# Access Compliance Report

## Public Rights-of-Way

Intersection ID: 10025513	Main Street: E_MOREHEAD_ST	Cross Street: N/A	Location: S
ADA ID: A54C1C1B091F	Ramp Type: BlendTrans1	Initial Pass/Fail: Fail	Overall Compliance: No
			Severity Score: 21.25

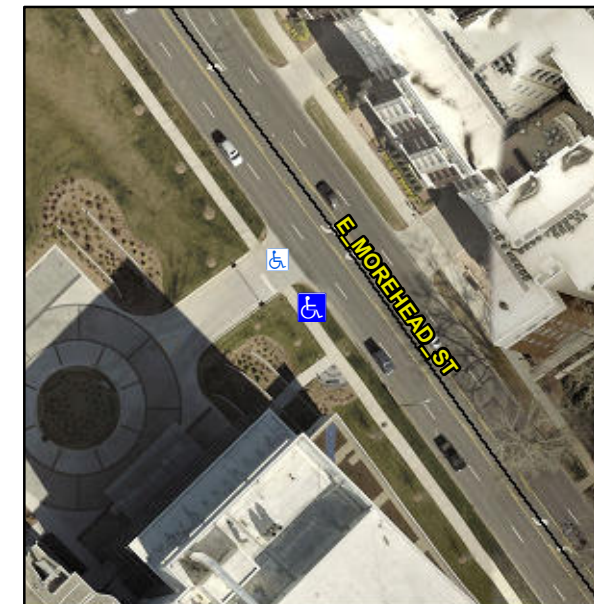
**Not Found, R304.5.1, R304.5.3**

Compliance	Description	Data	Compliance	Description	Data
N/A	Ramp Length (in)	108.0	Yes	BlendTrans Slope (%)	0.5
No	Ramp Width (in)	46.0	No	BlendTrans XSlope (%)	5.3
N/A	Flare Type LT	N/A	N/A	Flare Type RT	N/A
N/A	Flare Slope LT (%)	N/A	N/A	Flare Slope RT (%)	N/A
N/A	Flare Traversable LT?	N/A	N/A	Flare Traversable RT?	N/A
N/A	Landing Length (in)	N/A	N/A	DWS Provided?	N/A
N/A	Landing Width (in)	N/A	N/A	DWS Contrast?	N/A
N/A	Landing Slope (%)	N/A	N/A	DWS Length (in)	N/A
N/A	Landing X Slope (%)	N/A	N/A	DWS Full Width?	N/A
N/A	Landing Curb? (Y/N)	N/A	N/A	DWS Offset (in)	N/A
N/A	Shared Landing?	N/A			
N/A	Gutter Ponding?	N/A	N/A	Gutter Slope (%)	N/A
N/A	Gutter Lip Ht (in)	N/A	N/A	Gutter X Slope (%)	N/A
N/A	Painted X Walk1?	No	N/A	Painted X Walk2?	N/A
	X Walk 1 Direction	To NW		X Walk 2 Direction	N/A
	X Walk 1 Width (in)	N/A		X Walk 2 Width (in)	N/A
	X Walk 1 Slope (%)	2.4		X Walk 2 Slope (%)	N/A
	X Walk 1 X Slope (%)	3.7		X Walk 2 X Slope (%)	N/A

N/A	Ramp inside XWalk1?	N/A	N/A	Ramp inside XWalk2?	N/A
	Road Slope (%)	3.7		Clear Space?	N/A
	Road X Slope (%)	2.4	N/A	Clear Space to XWalk (in)	N/A
N/A	Any Obstructions?	N/A	N/A	Storm Grate/Utility Hazard?	N/A
	Obstruction Type			Storm Grate/Utility Type	
		N/A			N/A
			Yes	Surface Condition? (G/P)	Good
			No	Curb Slope (%)	13.0

**Remove & Replace Curb Ramp With Two New Directional Ramps or Equivalent.**
